1970 - 1973 Corvette: Service Bulletin: Overheating - 454 Cu.In. Engine with Air Conditioning

73-T-28

Subject: ENGINE OVERHEAT - 1970-1973
CORVETTES WITH 454 CU. IN.
ENGINES AND AIR CONDITIONING

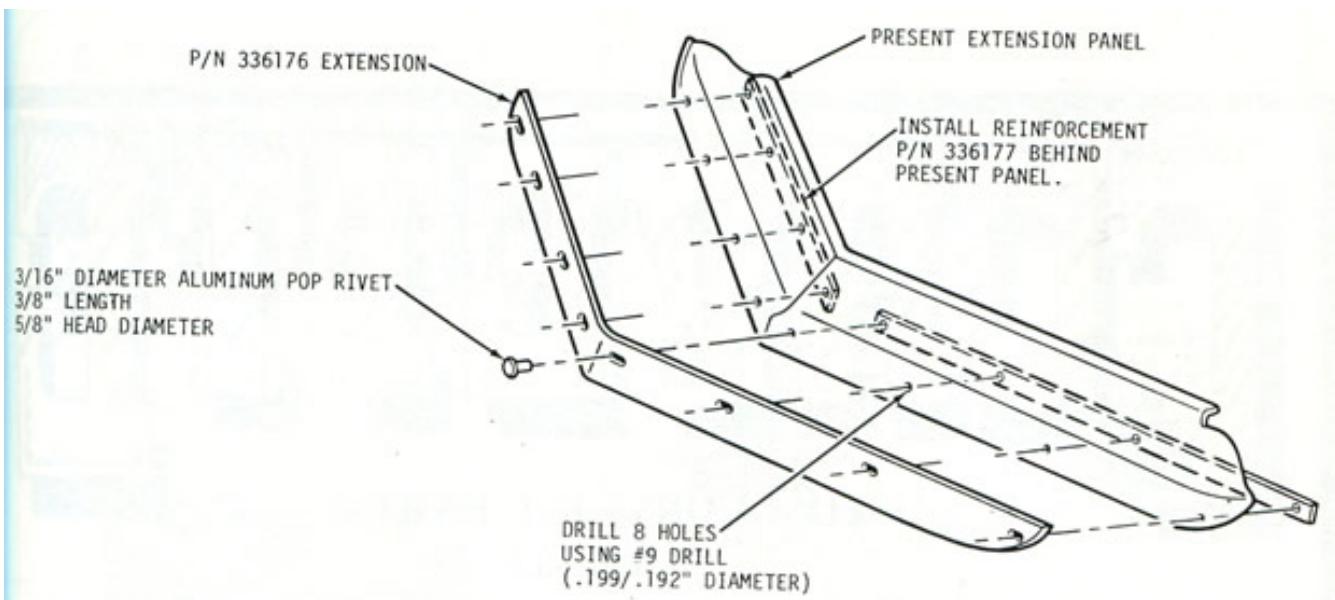
To improve low speed cooling, an additional grille panel lower extension was installed in 1973 Corvettes produced after Vehicle Identification Number 1Z3723S410722. This extension, Part Number 336176, may be installed as illustrated on page 2 of this bulletin on early 1973 Corvettes only.
